ADDENDUM 4

Bid #2023-24: 267 CANAL STREET REMEDIATION

BIDDING QUESTIONS & ANSWERS

EROSION CONTROL BLANKET INSTALLATION
NO SCALE

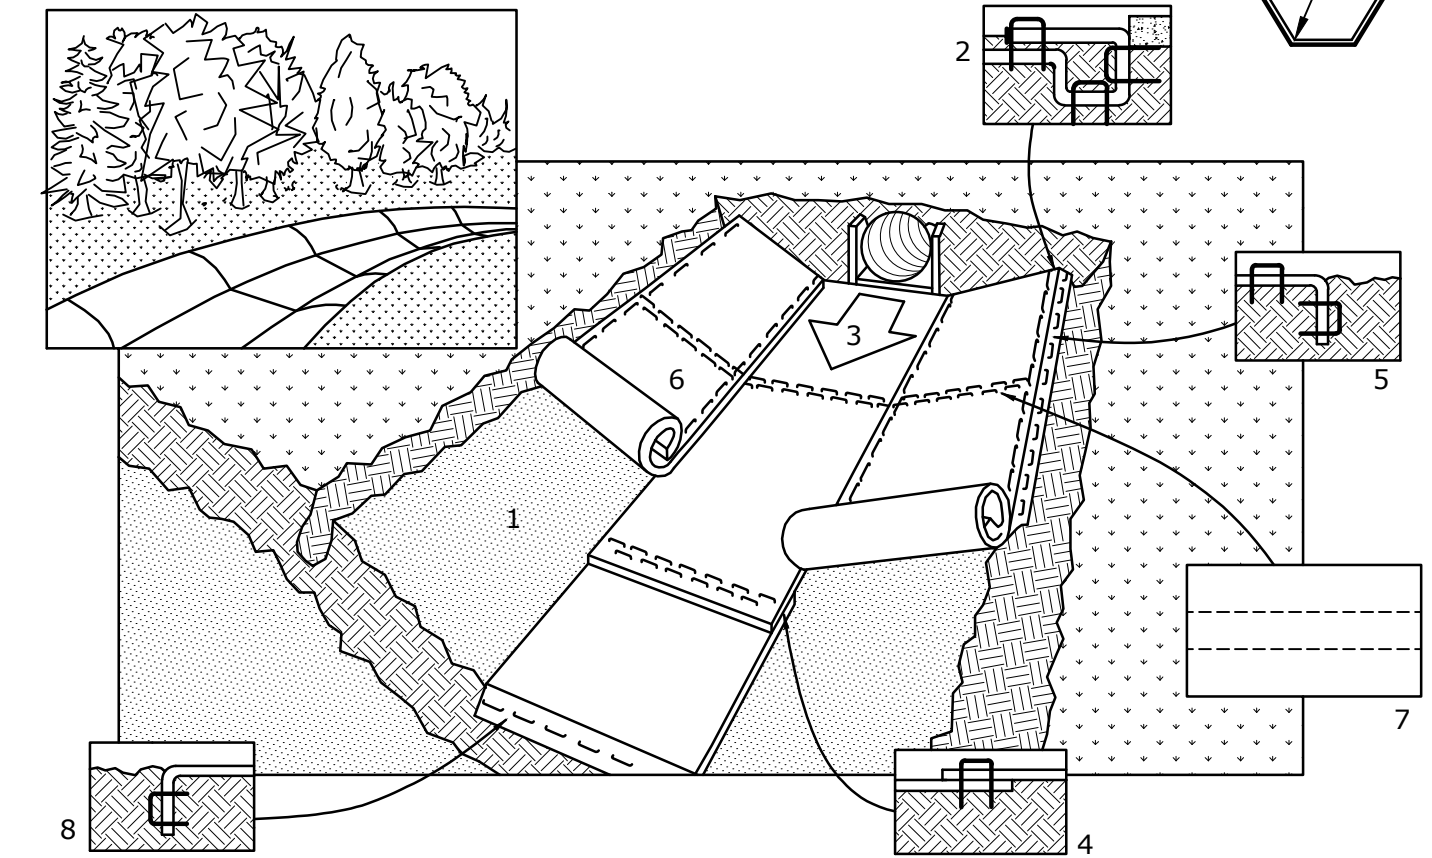
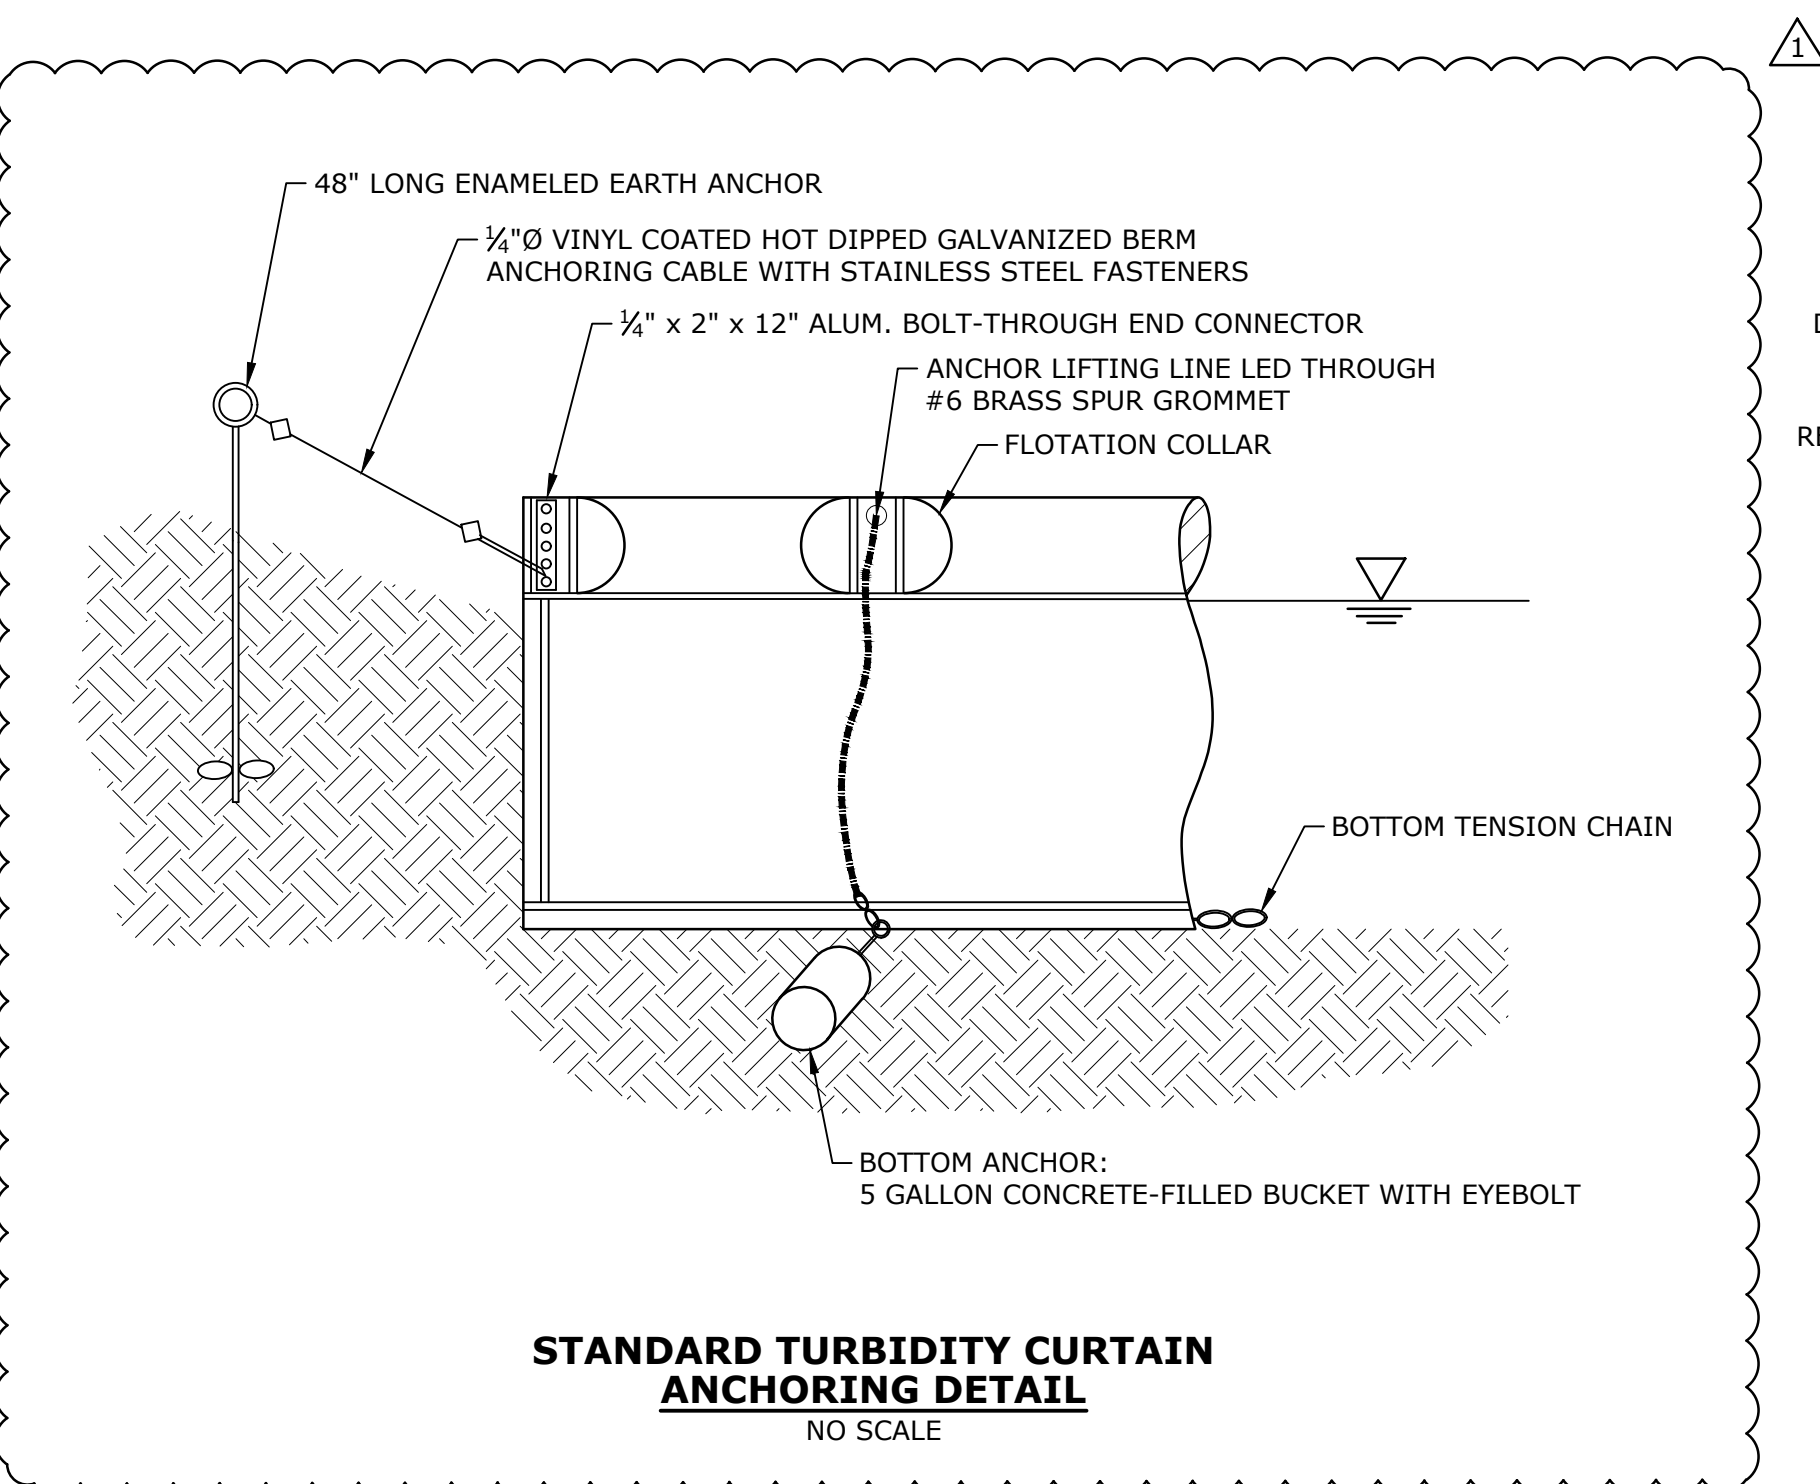
Drawing C-301 shows an area with the proposed Erosion Control Blanket.

- **Please provide a specification for the erosion control blanket to be used so the Contractor can price this material accordingly.**

- **Is the Contractor expected to seed the area that will be covered by erosion control blanket?**

Number Two. Drawing C-302 shows a erosion control blanket but I do not see anywhere on the drawings it going please explain'

Disregard the erosion control blanket. It will not be required for the project.

Disregard the erosion control blanket. It will not be required for the project.

Disregard the erosion control blanket. It will not be required for the project.

TURBIDITY CURTAIN DETAIL
NO SCALE

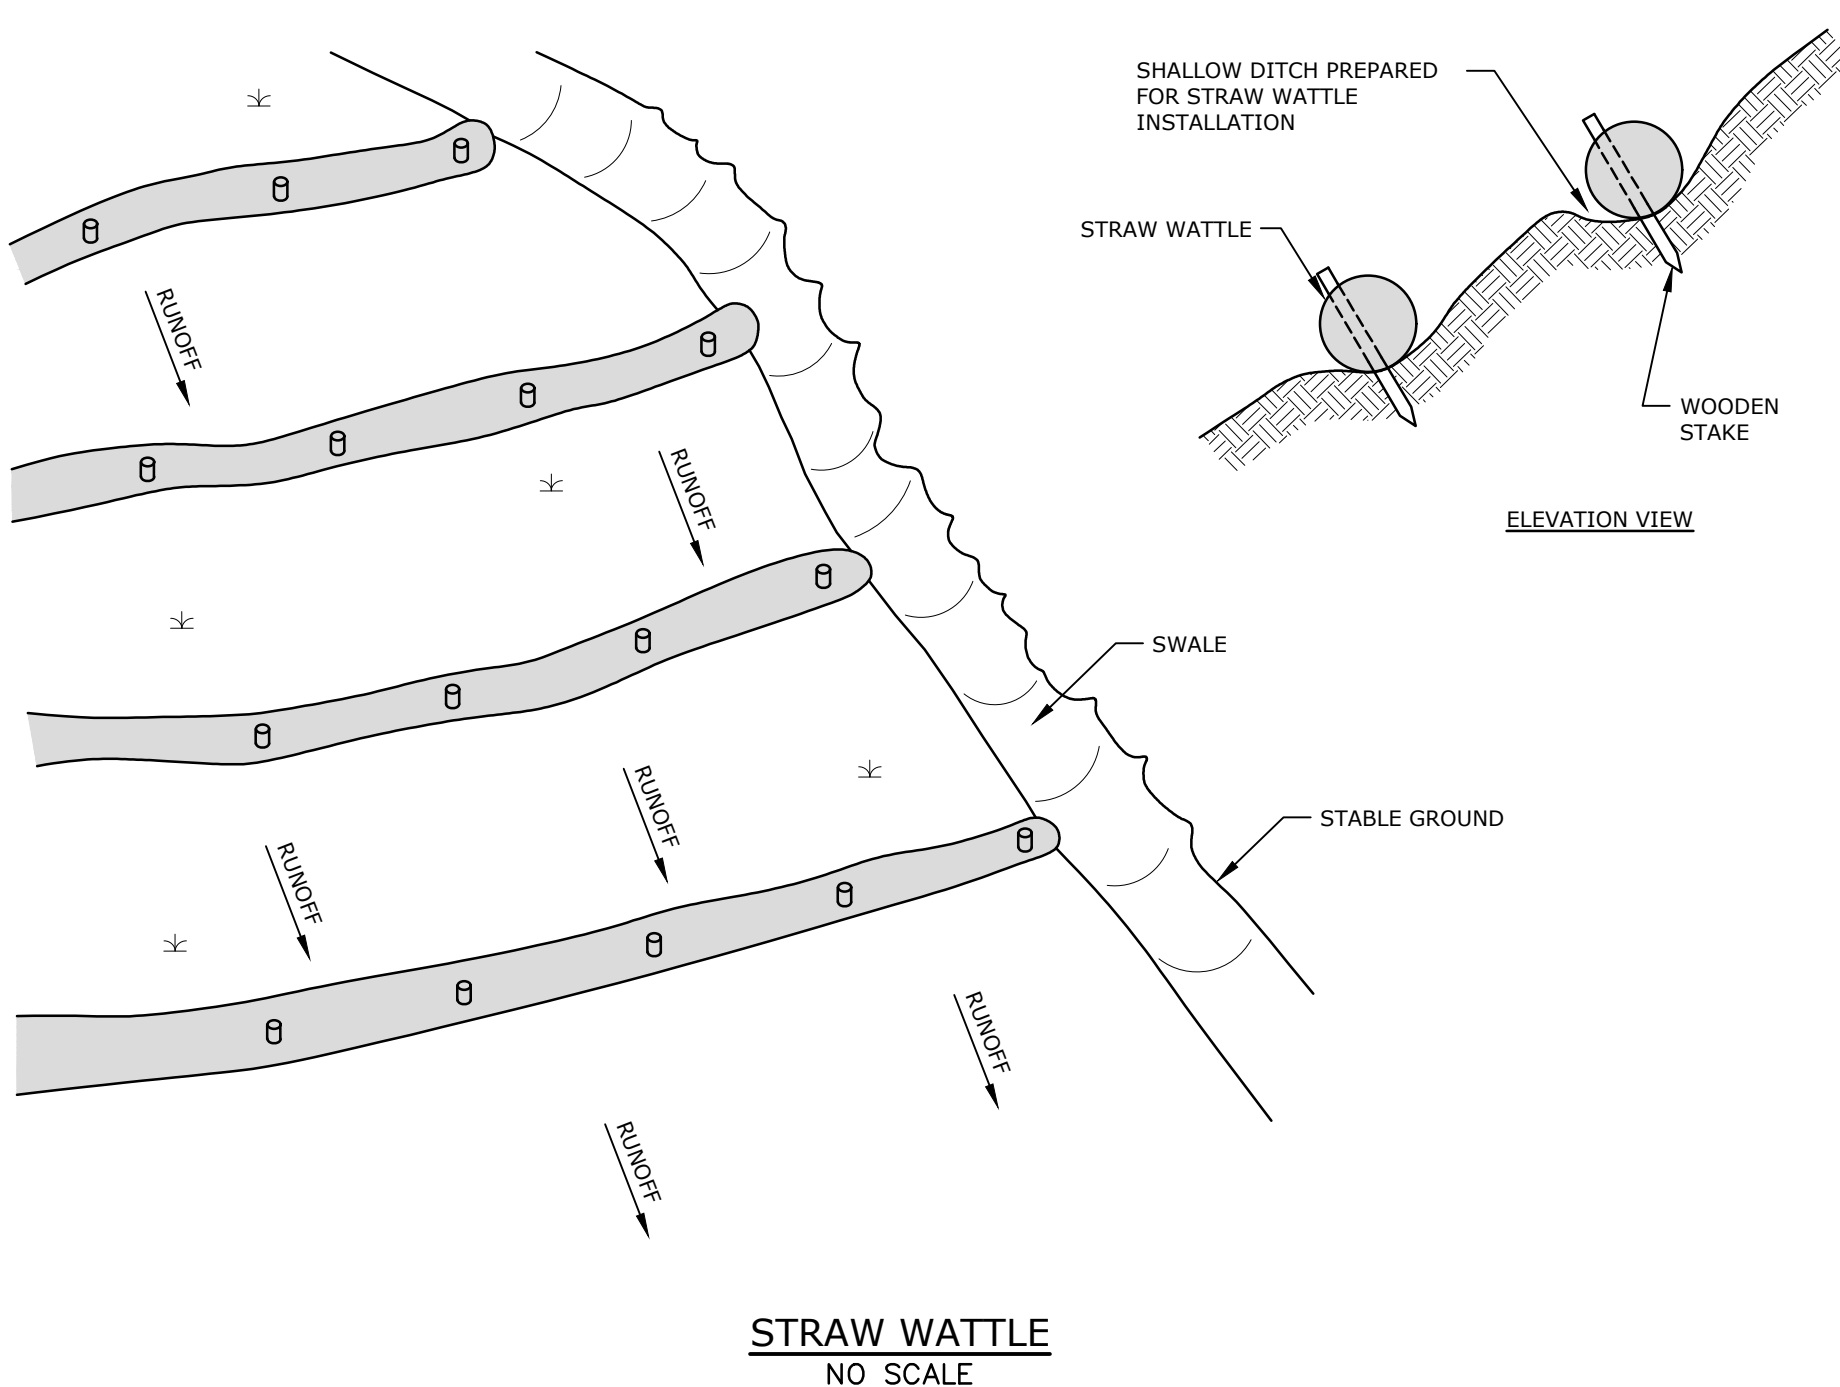
A turbidity curtain is shown to be installed along the river. Please provide a detail or specifications if a specific turbidity curtain is to be used, so the Contractor can include the right one.

Drawing C-302 Soil Erosion and Sedimentation Control Notes and Details has been updated and enclosed.
